PLANNING ACTION: PA-T2-2018-00002

SUBJECT PROPERTY: 880 Park Street

DESCRIPTION: A request for Site Design Review approval to construct a 15-unit apartment complex consisting of six apartment buildings, a separate 221 square foot laundry facility and a 30-space parking lot for the property at 880 Park Street. The application includes requests for Exception to the Street Standards to retain the existing asphalt multi-use path along Siskiyou Boulevard and to construct a meandering sidewalk along the subject properties Park Street frontage rather than installing new city standard sidewalks and parkrow planting strips, and for a Tree Removal Permit to remove five trees greater than six-inches in diameter at breast height (d.b.h.), including two Green Ash (*Fraxinus pennsylvanica*), one Modesto Ash (*Fraxinus velutina*), and two Redwoods (*Sequoia sempervirens*) including a multi-trunked cluster with five trunks of diameters ranging from eight- to 14-inches d.b.h. **Note:** An existing approximately 895 square foot shop building on the southeastern portion of the property would be demolished as part of the proposal. **COMPREHENSIVE PLAN DESIGNATION:** High Density Multi-Family Residen

Park Street Sidewalks

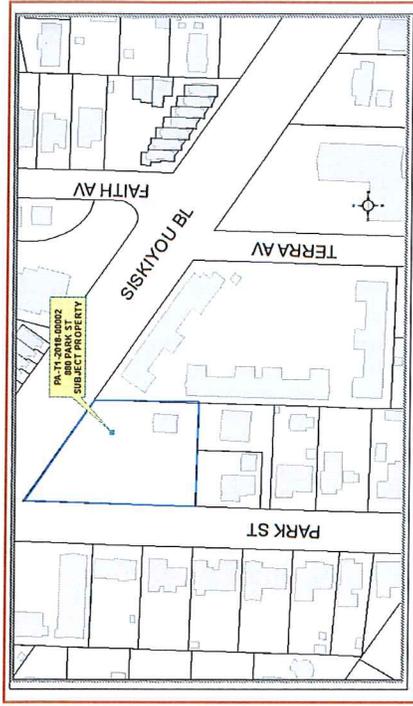
The applicants propose a meandering sidewalk to accommodate the placement of power poles. In staff's view, if arms cannot be installed on the poles to accommodate a standard sidewalk/parkrow configuration, a continuous curbside sidewalk would provide a better pedestrian facility and is likely the pattern that would continue on Park Street.

Tree #7

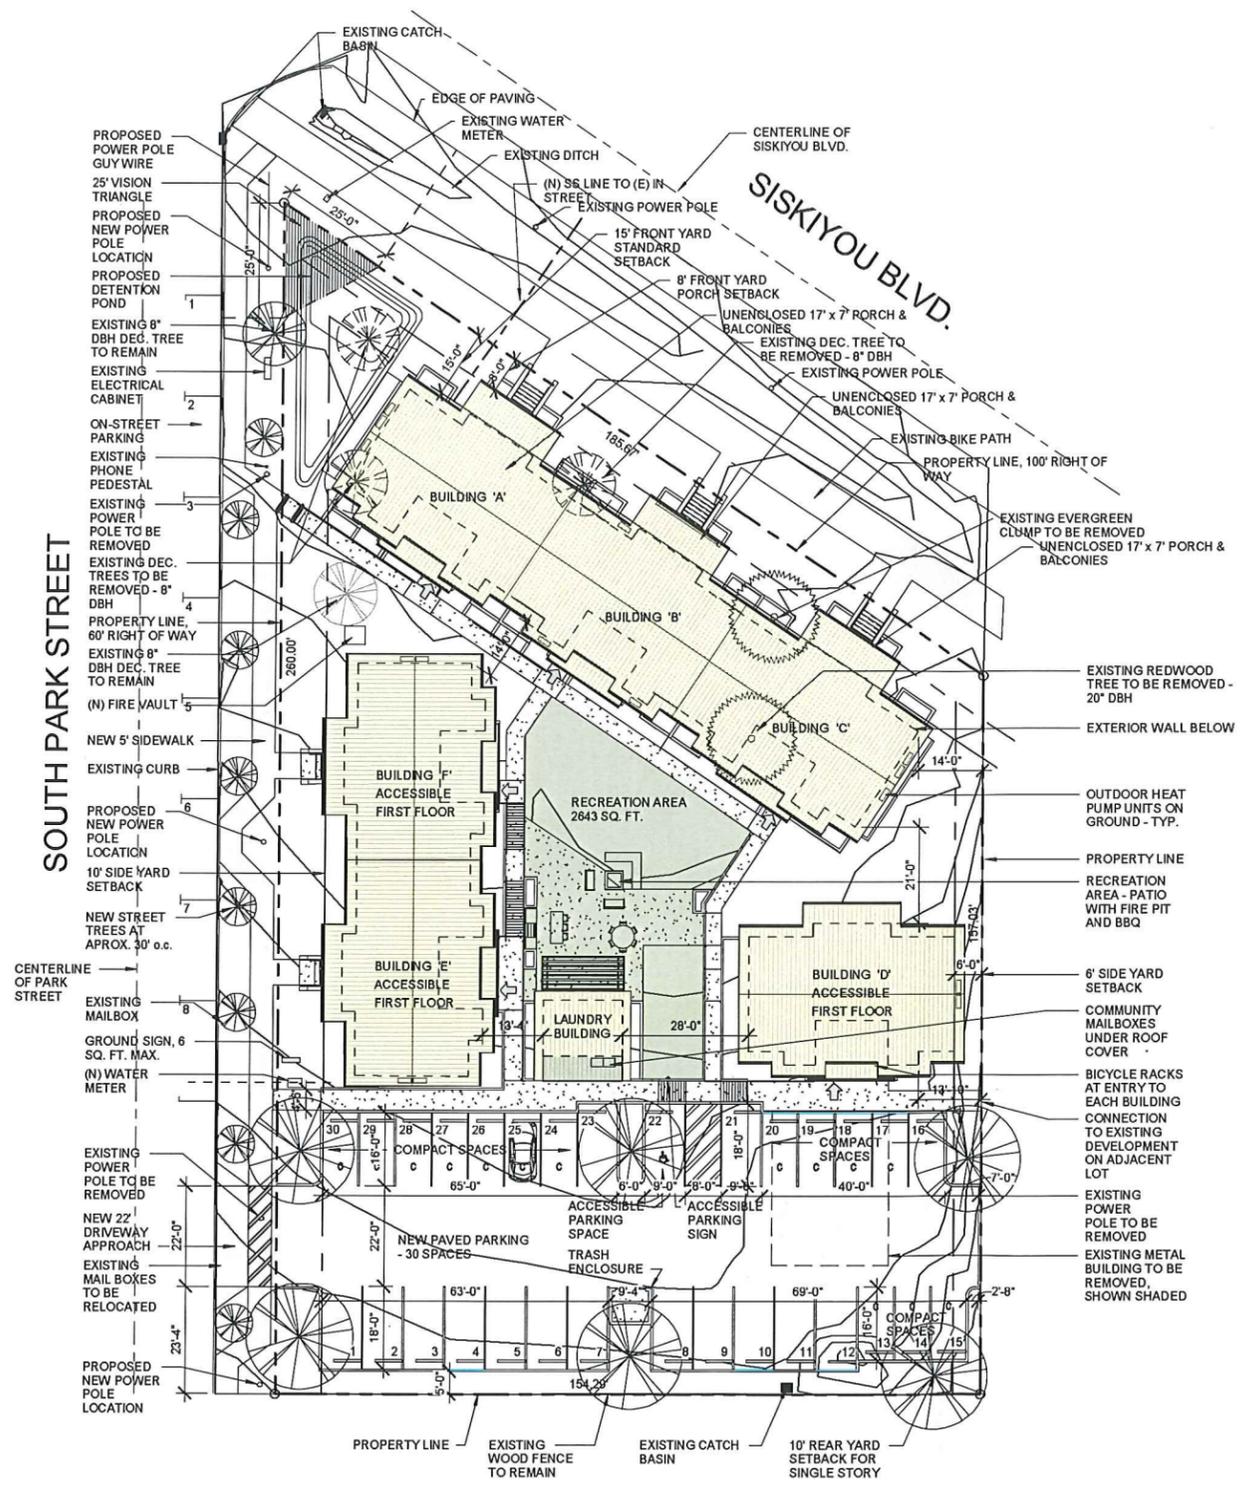
Redwood *Sequoia sempervirens*. Multiple trunks measuring: 11, 8, 10, 12, and 14 inches DBH. The plan calls for the removal of this tree. The tree does not appear to fall within the building footprint. It seems feasible that this tree could be preserved through tree protection measures, but would require adjustment of landscaping plans.

When considering the redwood trees (#6 and #7) for preservation I recommend some due diligence in addressing how these coniferous trees may be treated with the potential adoption of a new City wildfire ordinance. If preserved, they would both be within 30 feet from the building, but I am unclear if this would necessitate their removal, or if they are of a

size large enough that fuels reduction pruning would suffice. If preserved, I recommend that an official more familiar with the new ordinance be consulted.
